=====
PennDOT BQAD Publications e-Notification
Bureau of Design
Bridge Quality Assurance Division
=====

Interim Revision to Bridge Standard Drawing(s)	BD-612M, Shts. 2 & 3
--	---------------------------------

Interim Revision to Bridge Standard Drawing(s)	BD-632M, "R.C. Box Culvert", sheets 1, 3, 5, 9 and 10, dated 12/29/2008. Deeper Inlet Apron Cutoff Walls, Impervious Wingwall Backfill and Multiple Opposing Apron Baffles.
--	---

Interim Revision to Bridge Standard Drawing(s)	BD-632M, "R.C. Box Culvert", sheets 1, 4, 5, 9 and 10, dated 12/29/2008. Clarification of Backfill Material - Type, Placement Limits and Preformed Drain at Weep Holes.
--	---

Interim Revision to Bridge Standard Drawing(s)	BD-628M, dated July 20, 2007, Sheet 35 – BRIDGE APPROACH SLAB CONNECTION DETAILS: Replacing “AN APPROVED EPOXY BONDING COMPOUND” with “BOND BREAKER”
--	---

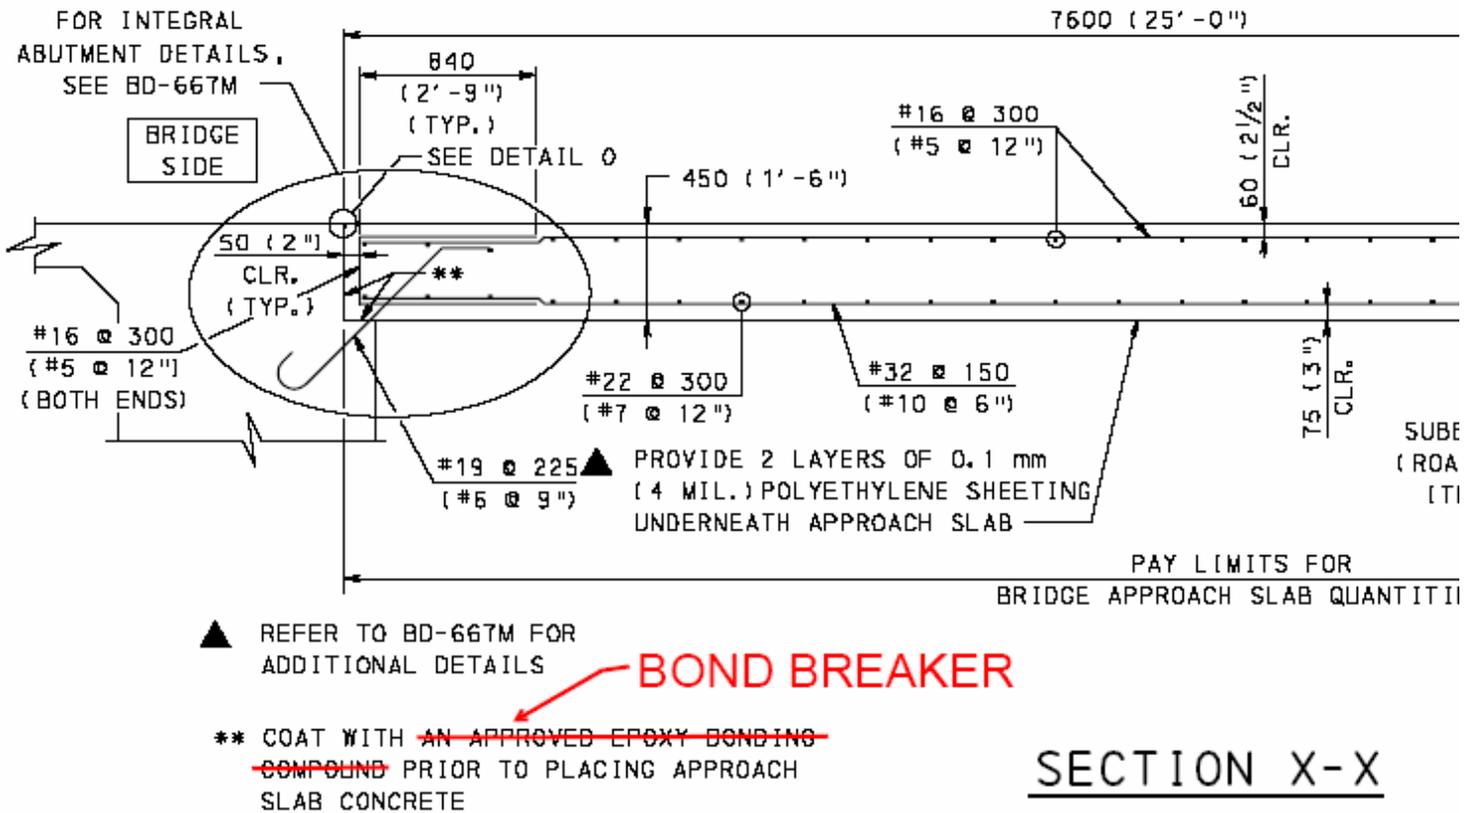
The intent is to permit rotation of the end of the Bridge Approach Slab Type 5 for integral abutments. To assure that this is possible, the following revision is needed to be made to SECTION X-X on BD-628M, Sheet 35:

- In ** Note, replace “AN APPROVED EPOXY BOUNDING COMPOUND” with “BOND BREAKER”.

BD-601M, dated July 20, 2007, Sheet 4 – RAISED SIDEWALK DETAIL: Clarification of 2% slope indication given in e-Notification No. 24
--

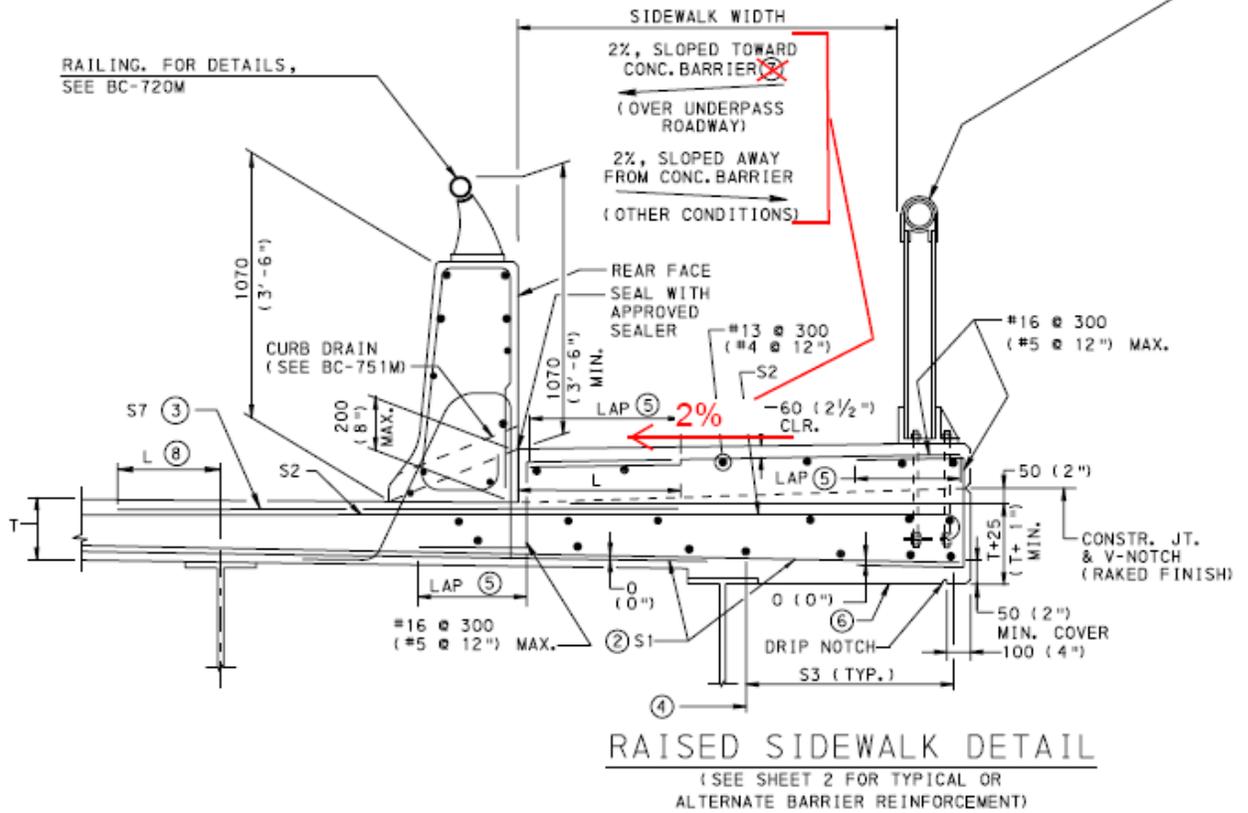
In RAISED SIDEWALK DETAIL of BD-601M, Sheet 4:

- The direction of the raised sidewalk's slope given in e-Notification No. 24 requires further clarification:
 - “2% slope with arrow” needs to be linked to the existing two call-outs located in the upper portion of this detail as shown on the attached 8.5”x11” page.
- Remove the Note 7 reference from the top call-out for sidewalk slope.

Interim Revision to Bridge Standard Drawing(s)	BD-655M, "TYPICAL SUPERSTRUCTURE SECTIONS", Sheet 1, dated December 29, 2008 INTERMEDIATE DIAPHRAGM - Elimination of Threaded Inserts from Prestressed Concrete I-Beam's bottom flange
--	---

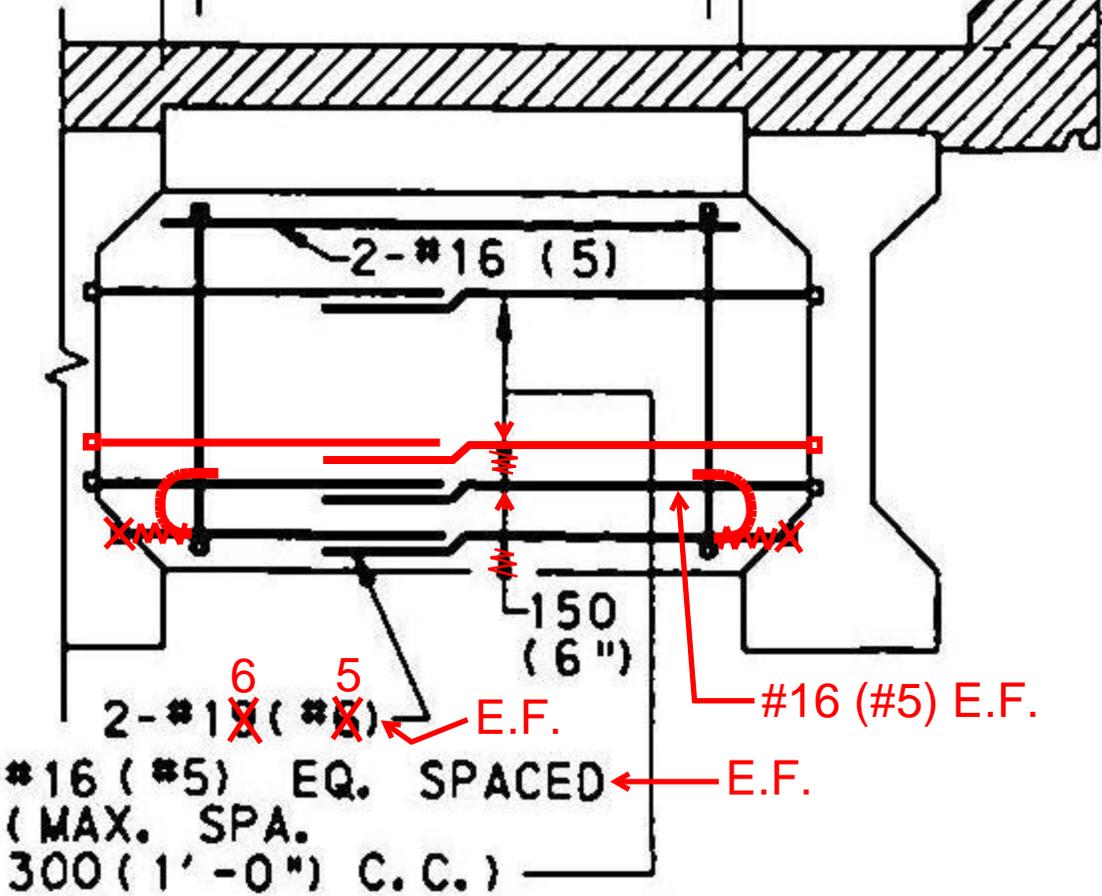
For the INTERMEDIATE DIAPHRAGM detail with vertical clearance less than 4880 (16'-0"): removed lower inserts in beam flange, added rebar at bottom of diaphragm with 180° hooks, and added #5 rebar with insert at 6" spacing.

RECOMMENDED JULY 9, 2010	RECOMMENDED JULY 9, 2010	SHEET 1 OF 11
CHIEF BRIDGE ENGINEER	DIRECTOR, BUREAU OF DESIGN	BD-632M

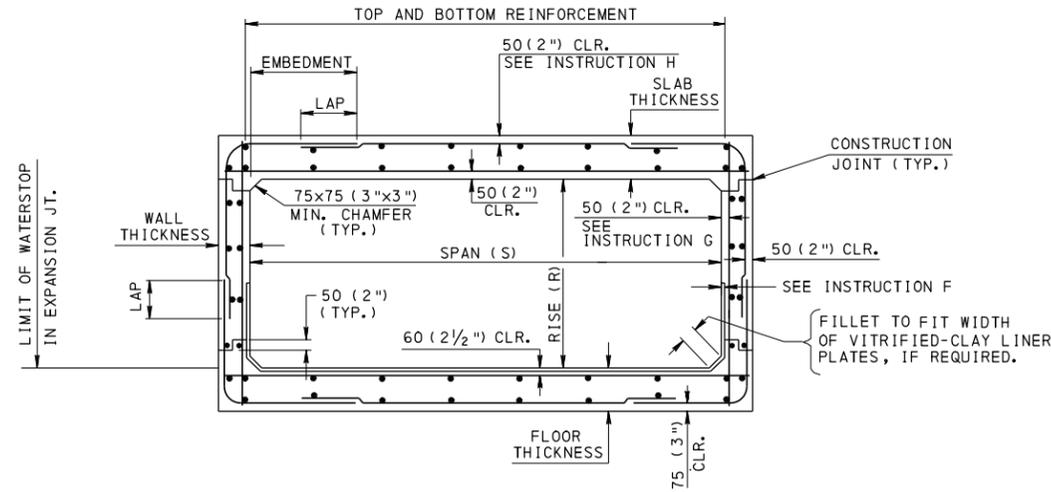
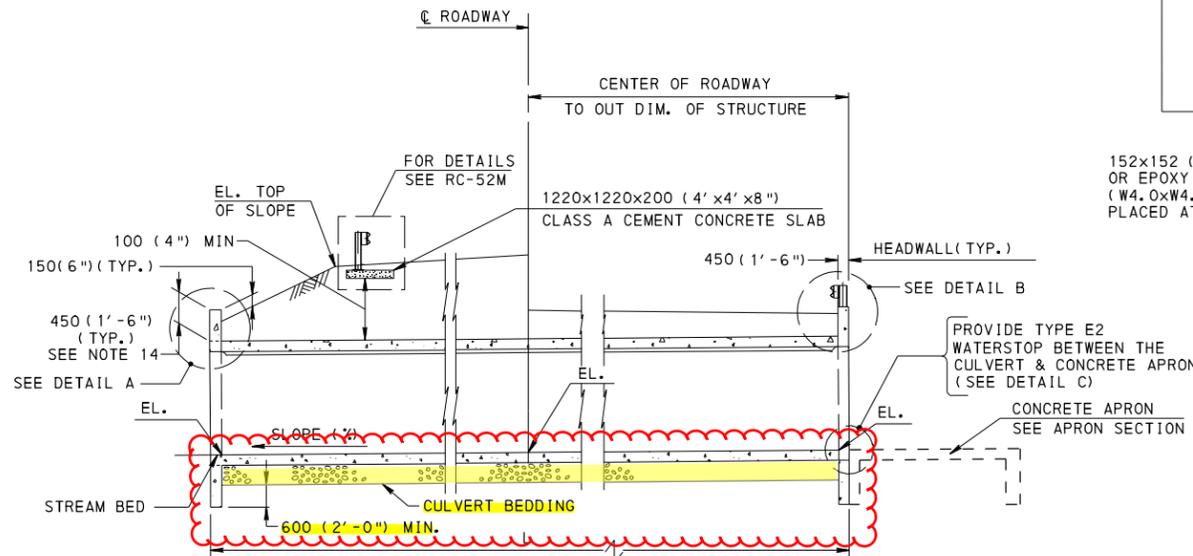
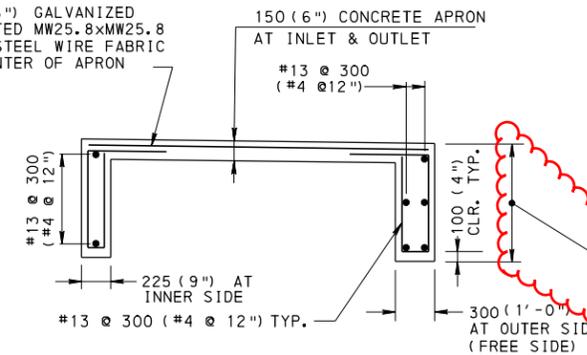
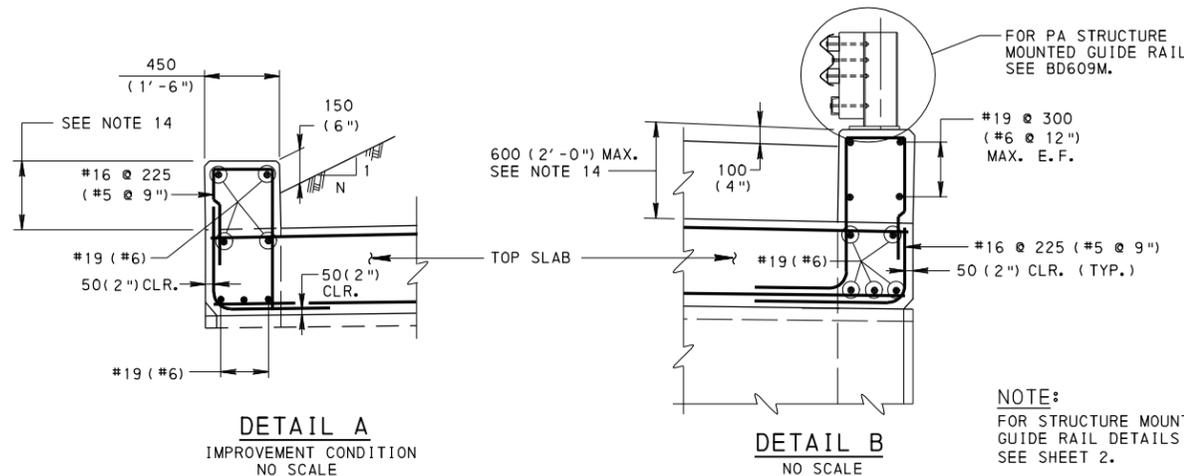
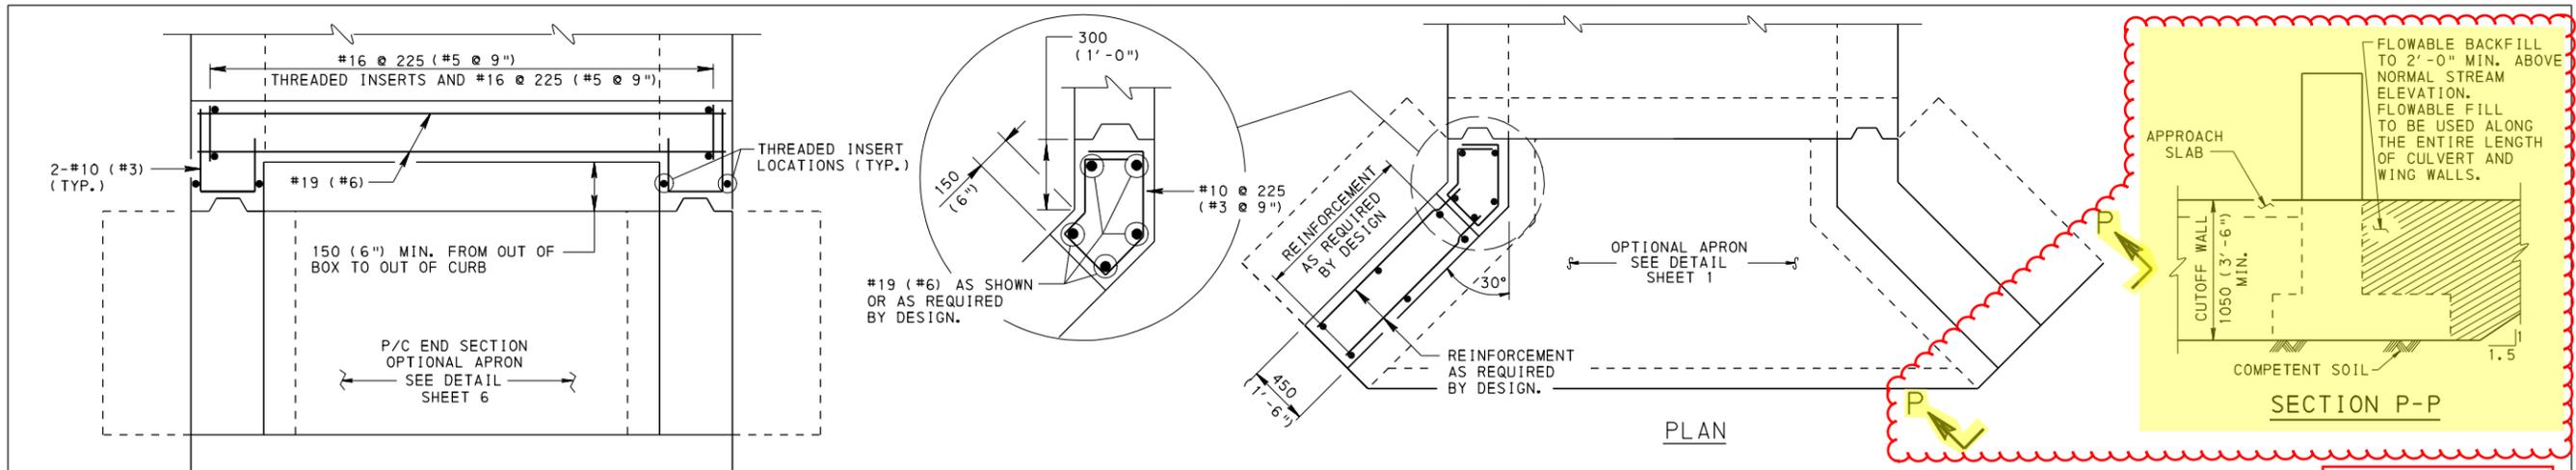
1. Inlet apron cutoff walls must be extended to the bottom of the wing wall footing or the bottom of the rock lining whichever is deeper (3'-6" min.). Note 18 is revised to require waterstop to be used at bottom slab in addition to top slab and walls. The purpose of this is to ensure that the stream flow does not pass beneath the culvert, thereby, reducing structural stability and reducing aquatic organism passage.

3. If an apron is greater than 8 feet long, a second set of opposing baffles is required to be $\frac{1}{2}$ the distance from the end baffles to the face of the box. For longer aprons, baffles are not to exceed 8-foot spacing. The purpose of this is to improved aquatic organism passage by reducing sheet flow and promoting sediment buildup to the baffle height on the aprons.

- Sheet 1 - Section along Centerline Culvert, Apron Section, and Note 18 revised
- Sheet 3 - Typical Headwall Section revised
- Sheet 5 - Precast End Section and Cast-In-Place Wingwalls revised
- Sheet 9 - Plan Views and Notes 2 & 7 revised
- Sheet 10 - Plan Views and Notes 2 & 7 revised

RECOMMENDED JULY 9, 2010	RECOMMENDED JULY 9, 2010	SHEET 5 OF 11
CHIEF BRIDGE ENGINEER	DIRECTOR, BUREAU OF DESIGN	BD-632M

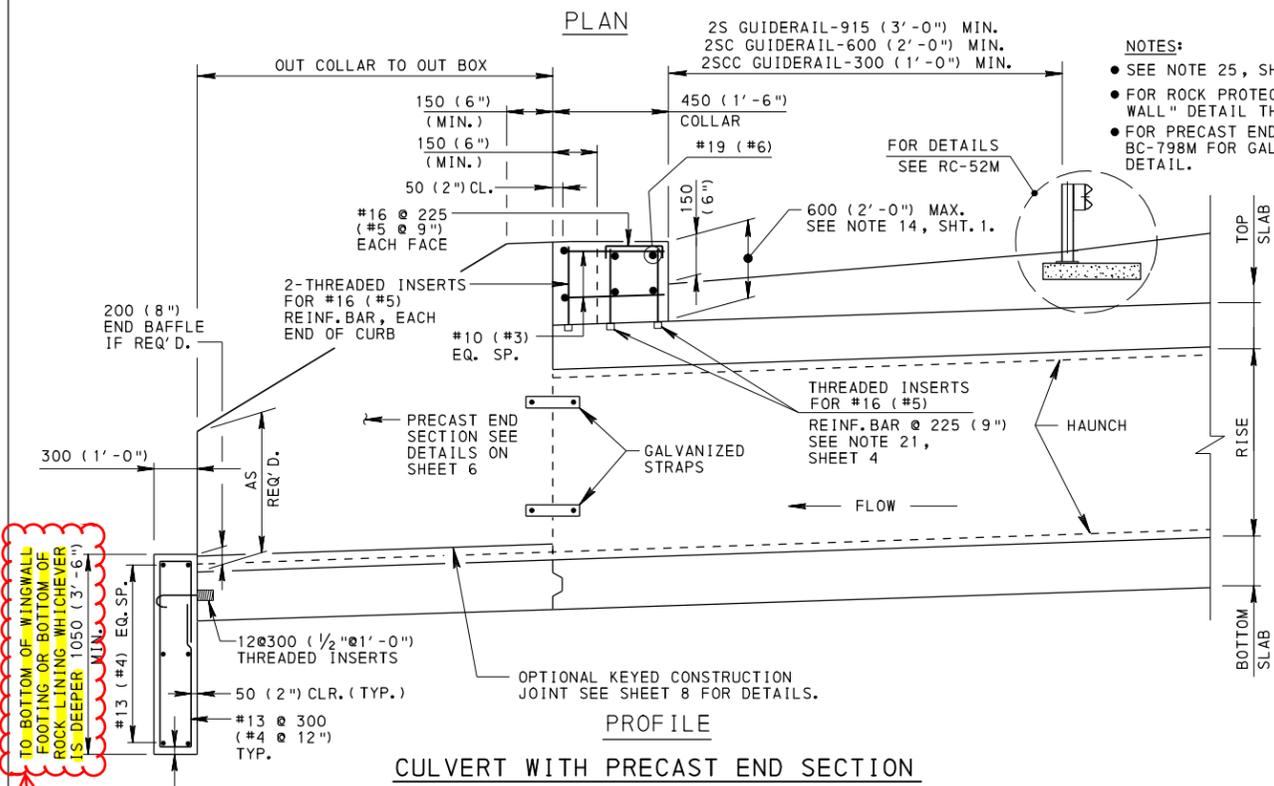
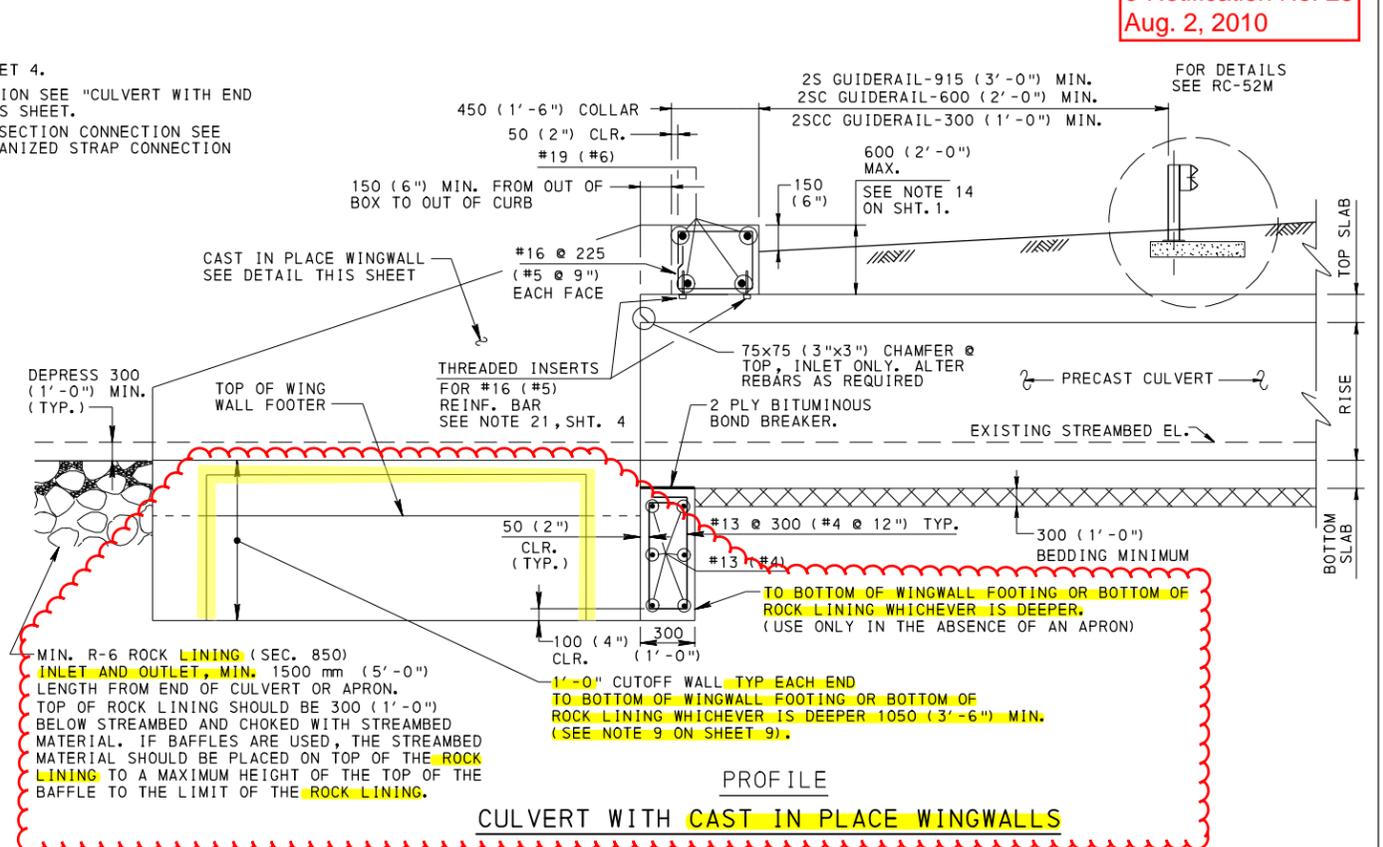
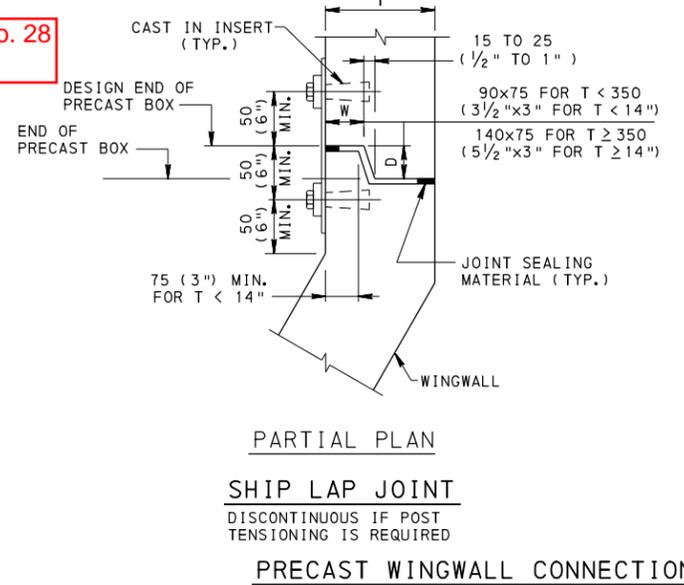
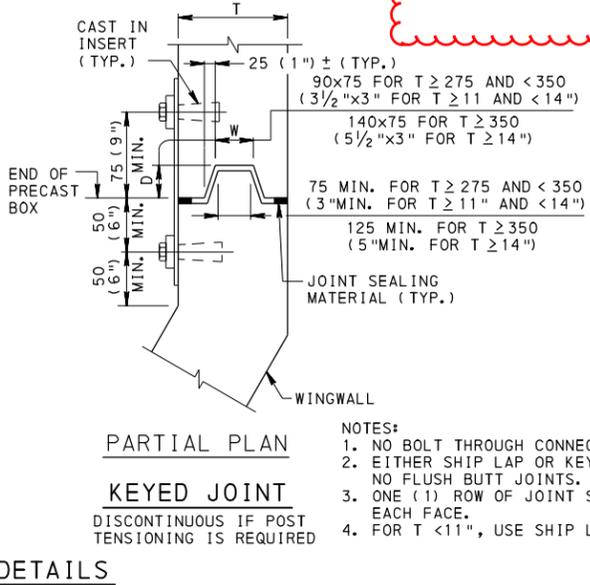
1'-0" CUTOFF WALL TYP EACH END TO BOTTOM OF WINGWALL FOOTING OR BOTTOM OF ROCK LINING WHICHEVER IS DEEPER 1050 (3'-6") MIN. (SEE NOTE 9 ON SHEET 9).
